Docket No. 217 - Development and Management Plan Inspection

Northeast Utilities Service Company Certificate of Environmental Compatibility and Public Need for the construction of a 345-kV electric transmission line and reconstruction of an existing 115-kV electric transmission line between Connecticut Light and Power Company's Plumtree Substation in Bethel, through the towns of Redding, Weston, and Wilton, and to the Norwalk Substation in Norwalk, Connecticut.

Date: November 10, 2005

Location: Overhead Line (Composite 345kV and 115kV Gallows Hill to Archers Lane)

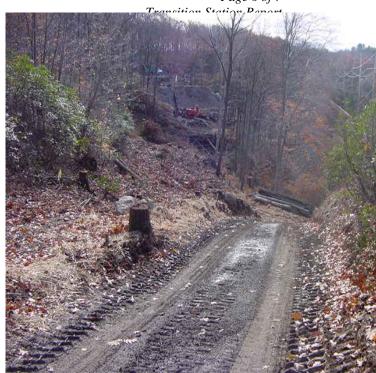
View of the low spot/wetland crossing on the access road in from Archers Lane. Standing water in the adjacent wetlands was clear and erosion controls are in good shape. 11/10/05
